ADDENDUM NO. 02

PROJECT NAME: Hemisfair Internal Street Improvements: Water and E. Nueva

DATE: October 8, 2014

TCI PROJECT NO.: **40-00421**

N.T.S.		SHEET 1 OF 3		
DSN: JMG	CK: SDT	DATE	JOB NO.	SHEET NO.
DRN: CRA	CK: -	SEPT. 2014	218609	9

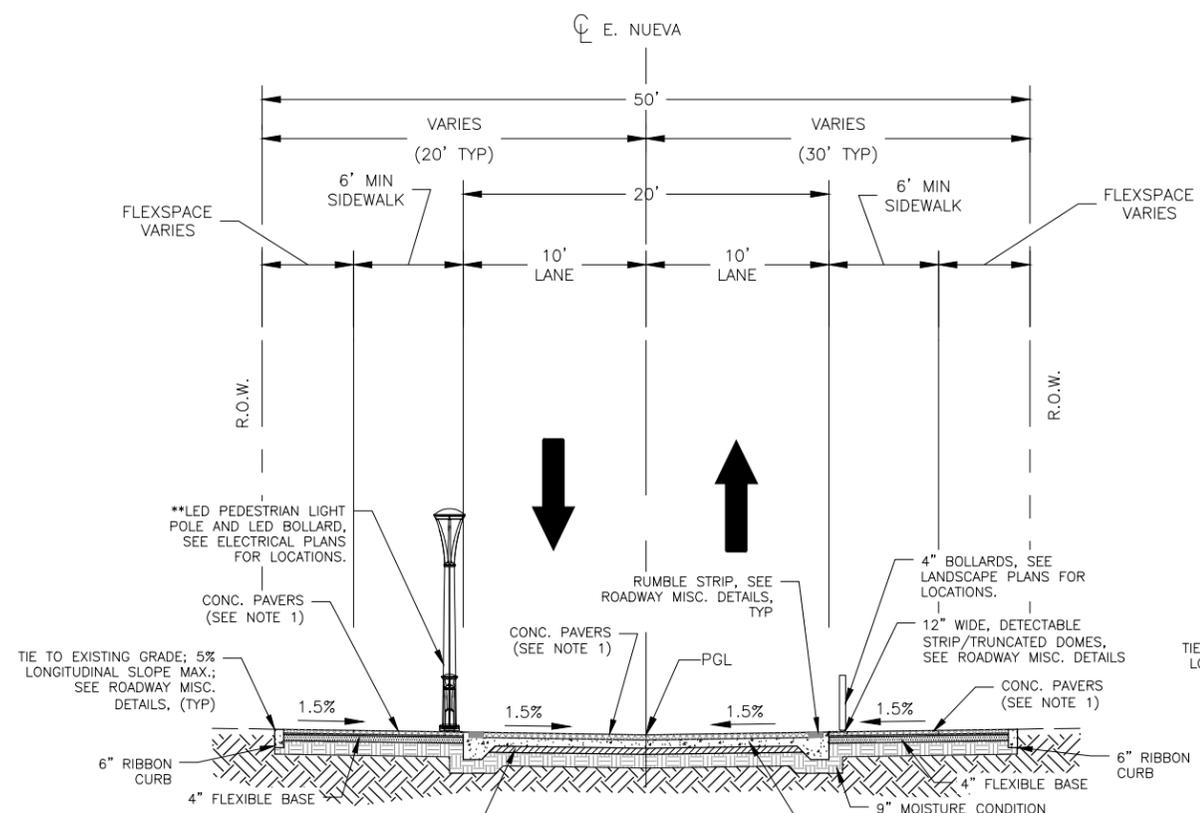
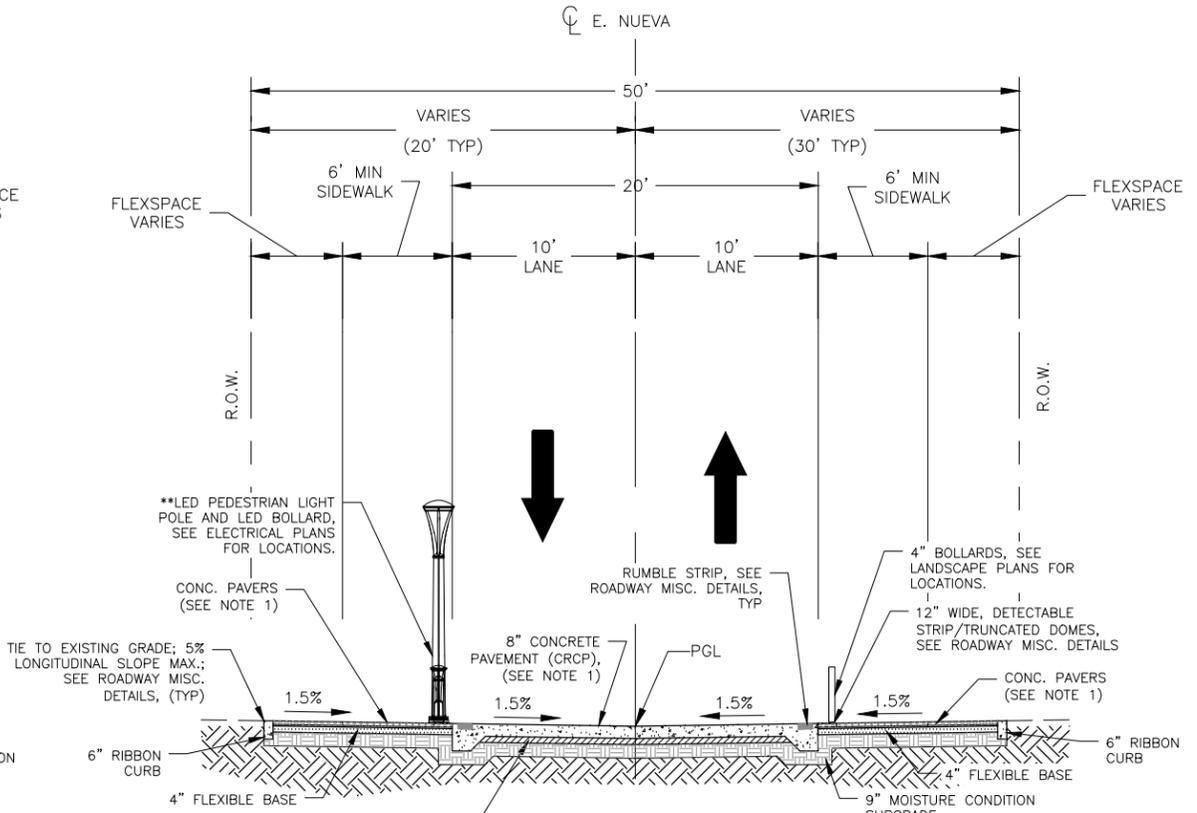
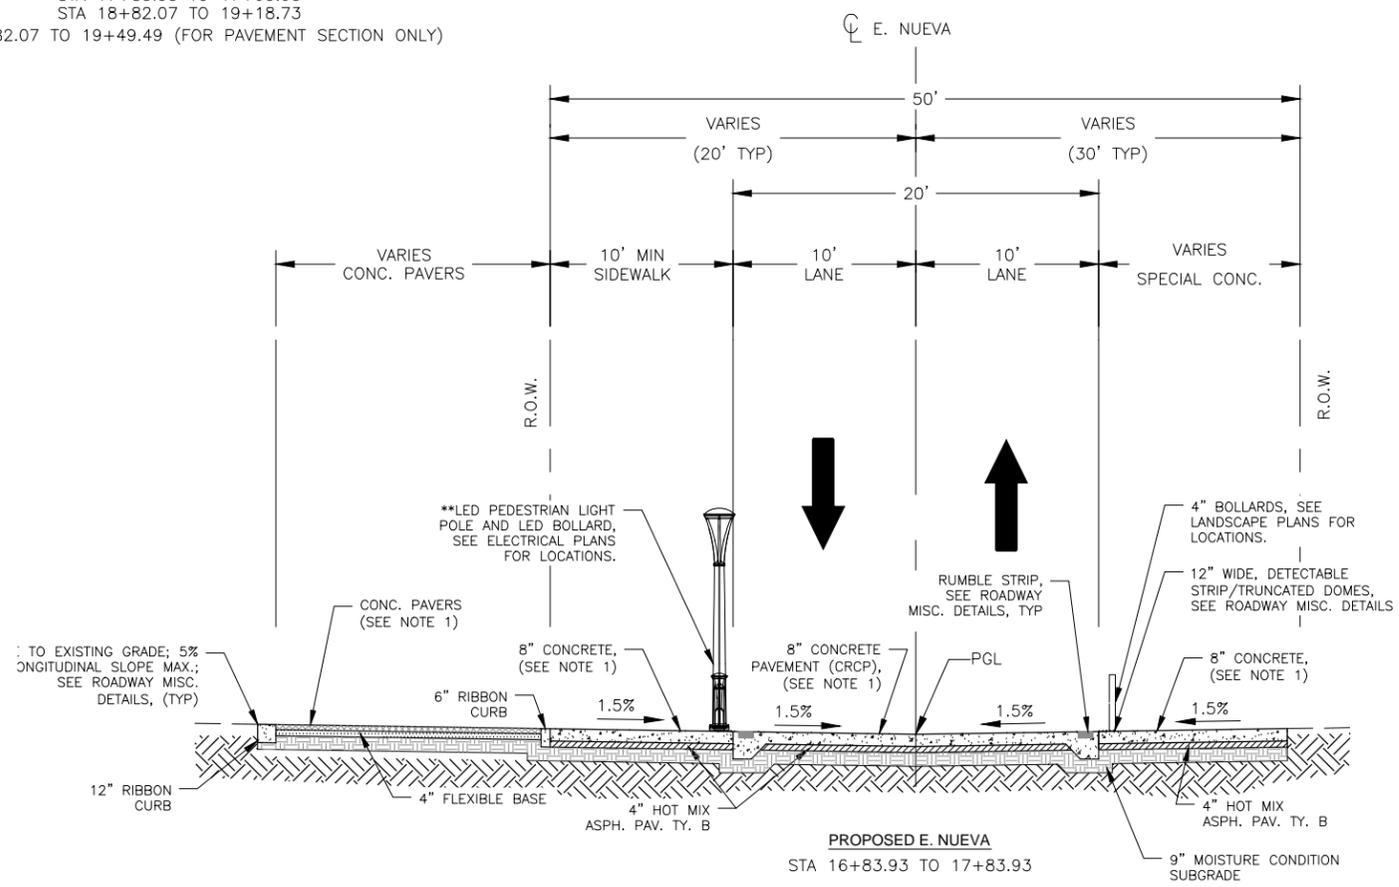
- Sheet 4 – Supplemental General Notes: Revised Notes 15 and 29.
- Sheet 9-11 – Proposed Typical Sections: Adjusted notes.
- Sheet 12-13 – Project Quantity Summary: Updated Quantities

DSN: JMM	CK: SDT	DATE	JOB NO.	SHEET NO.
DRN: CRA	CK: -	SEPT. 2014	218609	23

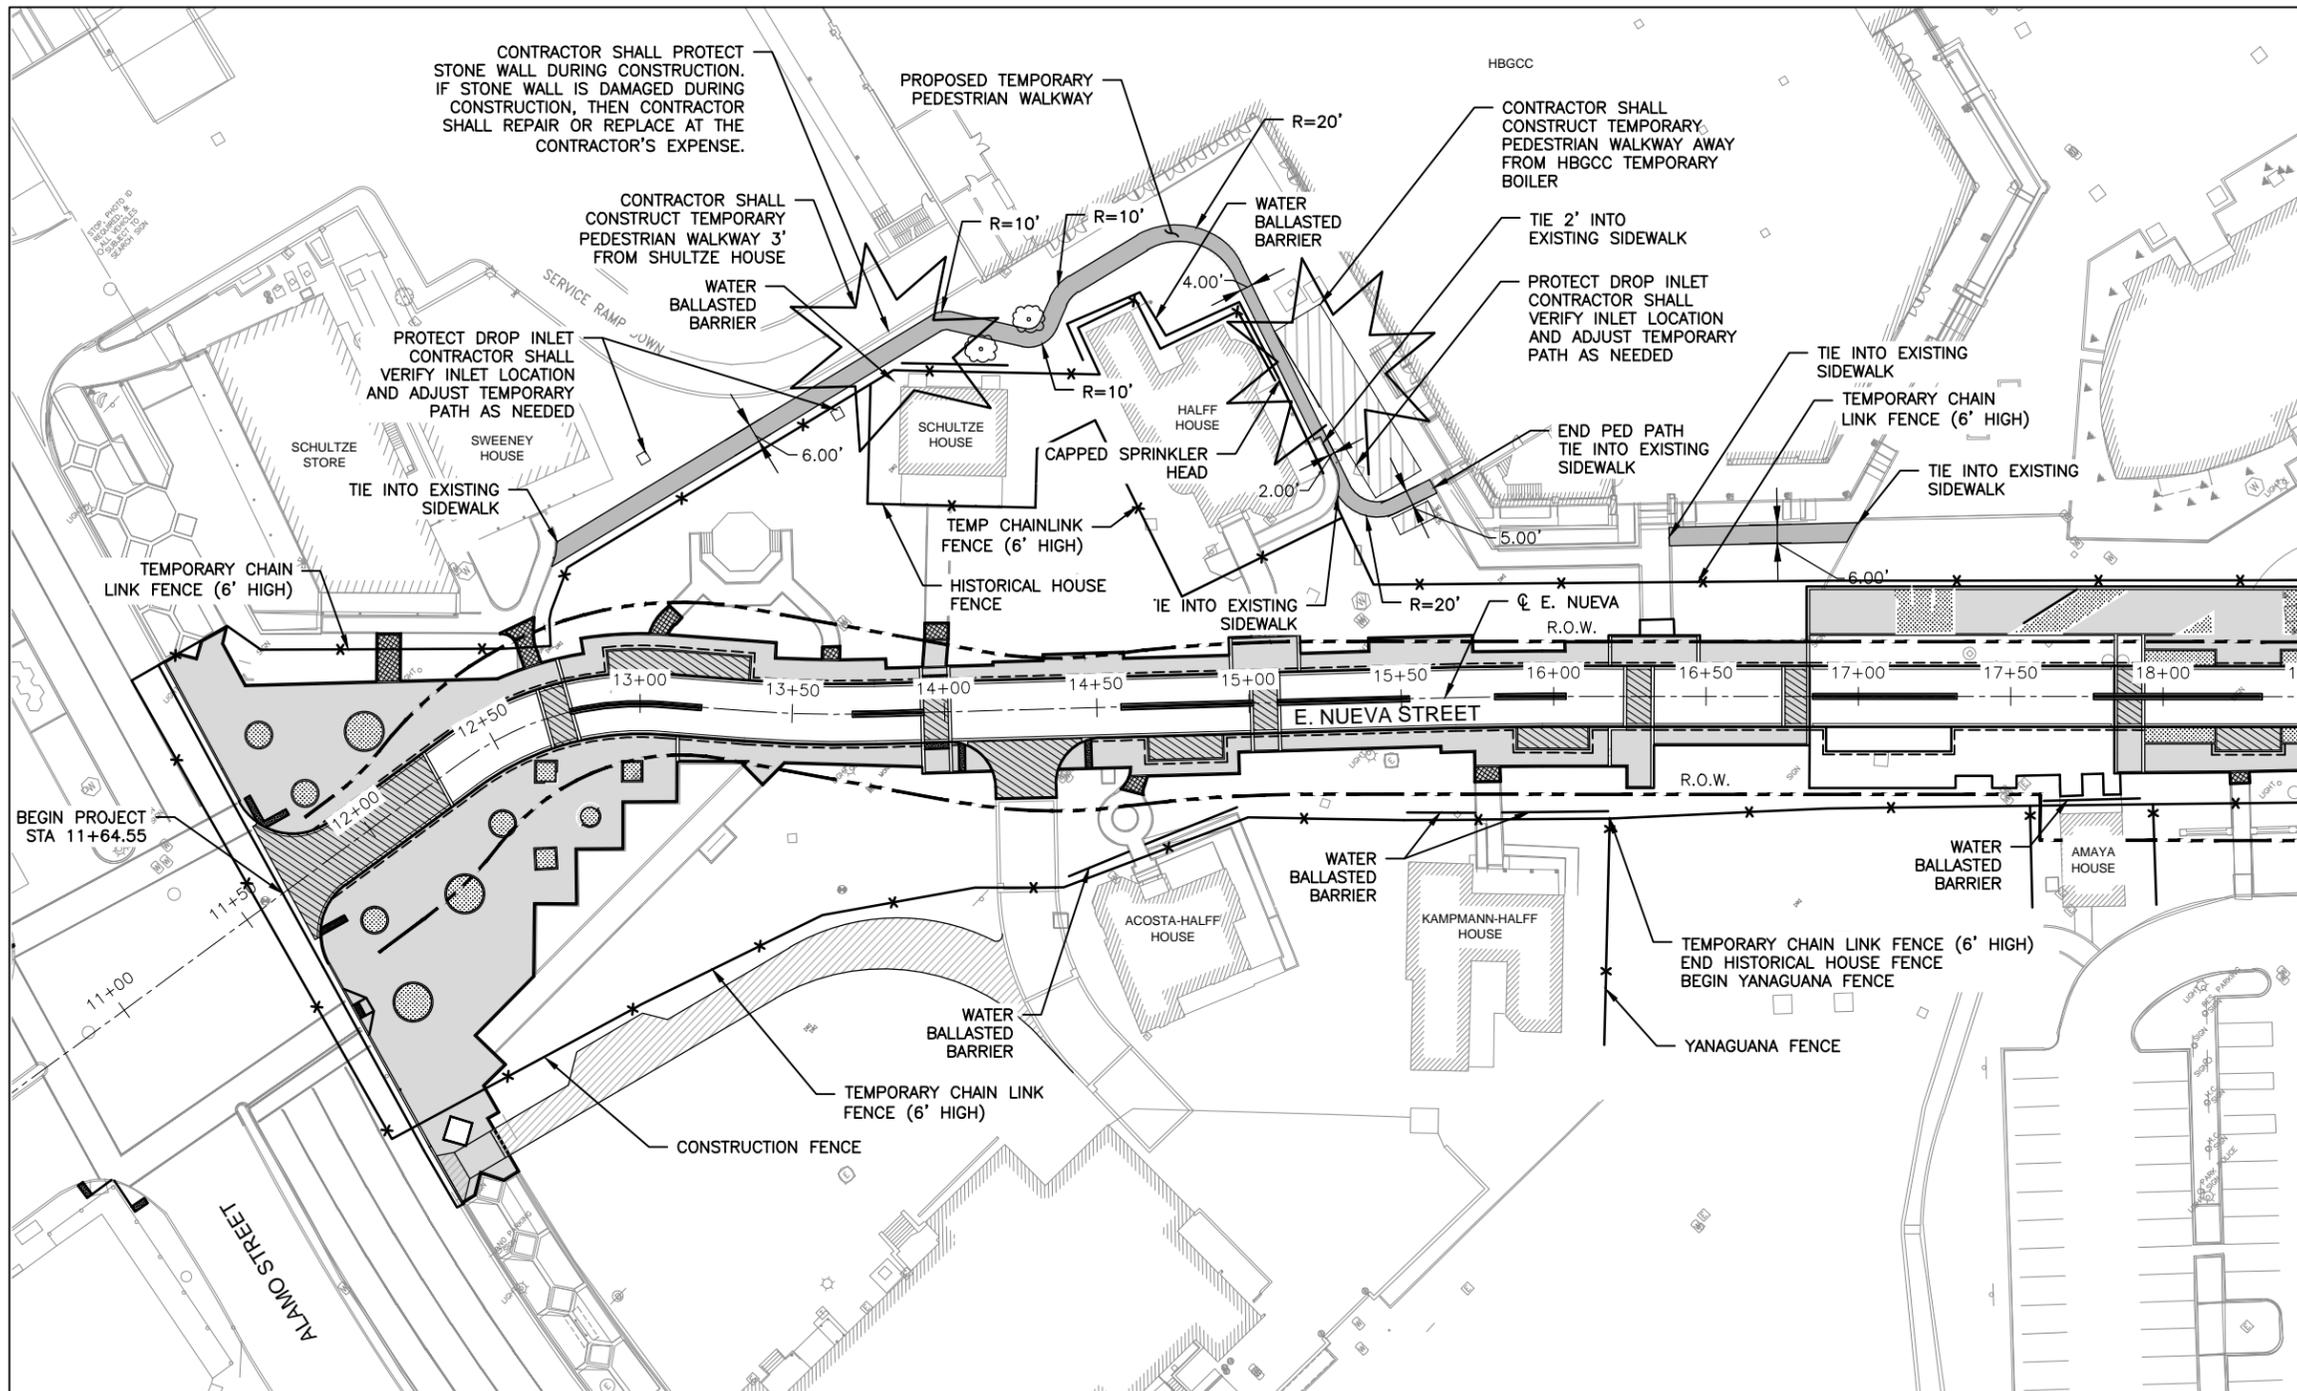
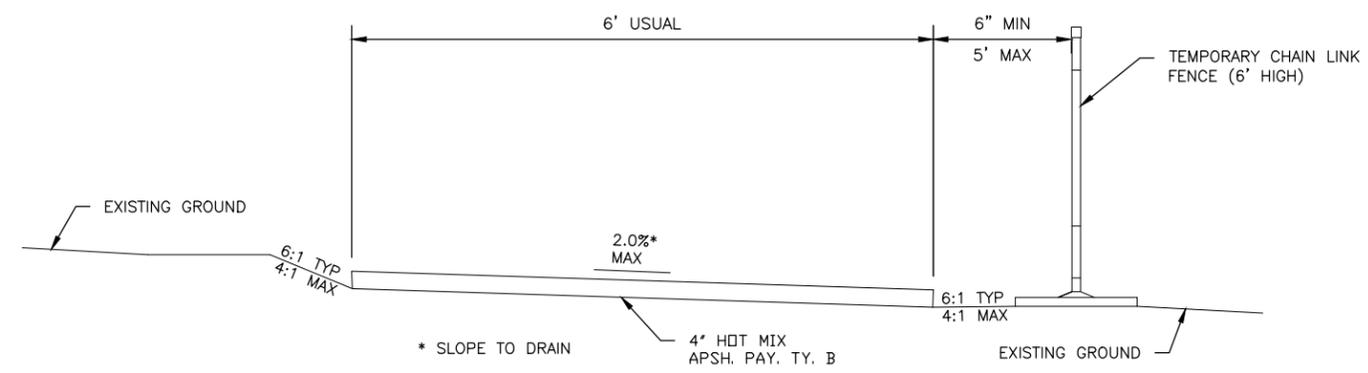
- Sheet 23 – Temporary Fence & Pedestrian Walkway: Updated roadway hatching
- Sheet 24 – Temporary Fence & Pedestrian Walkway: Updated roadway hatching
- Sheet 57 – Temporary Emergency Service Drive: Updated roadway hatching

- Note 6 on sheet 23 states that pedestrian walkway and grading shall be paid under 900.10 Temporary pedestrian walkway. Can a pay item be added for this? **A pay item is included on Page 4 of the 025 Unit Pricing Form**

DSN: JMG	CK: SDT	DATE	JOB NO.	SHEET NO.
DRN: CRA	CK: -	SEPT. 2014	218609	60

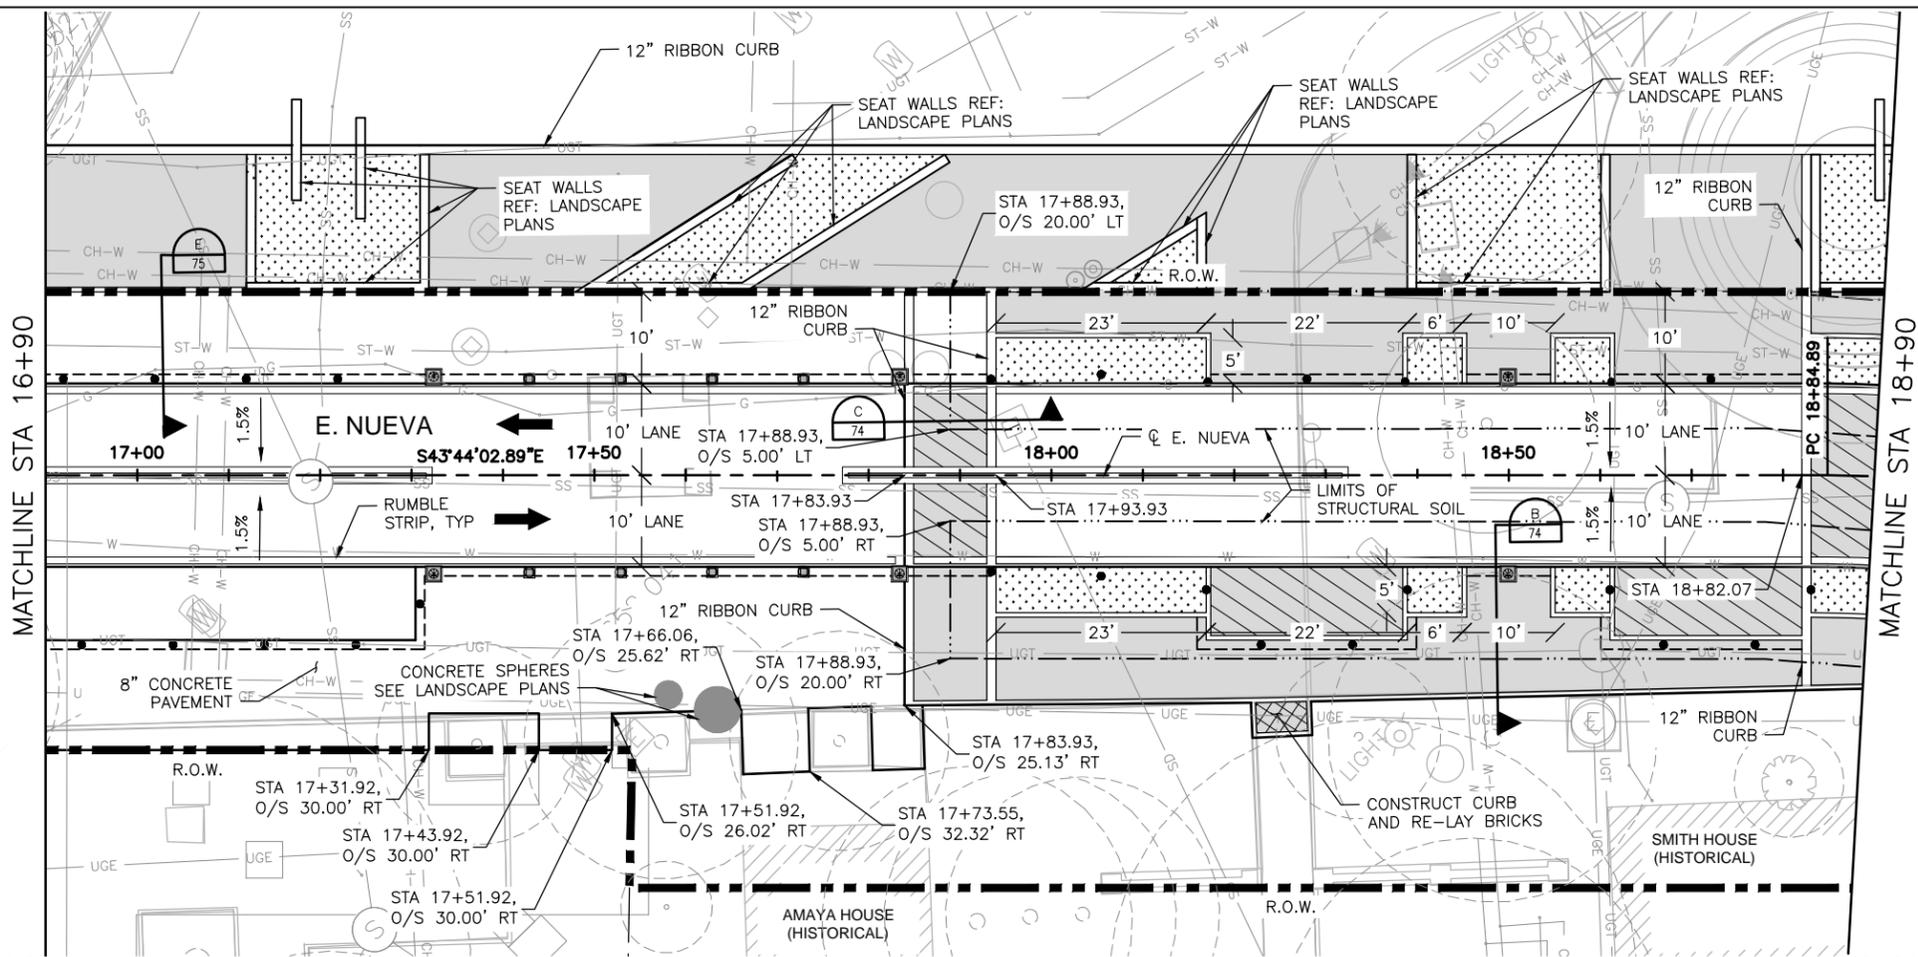
- Sheets 59-65 – Plan and Profile: Updated roadway hatching
- Sheet 67 – Plan and Profile: Updated roadway hatching
- Sheet 71 – Grading Plan: Updated roadway hatching, Added callout for combination curb
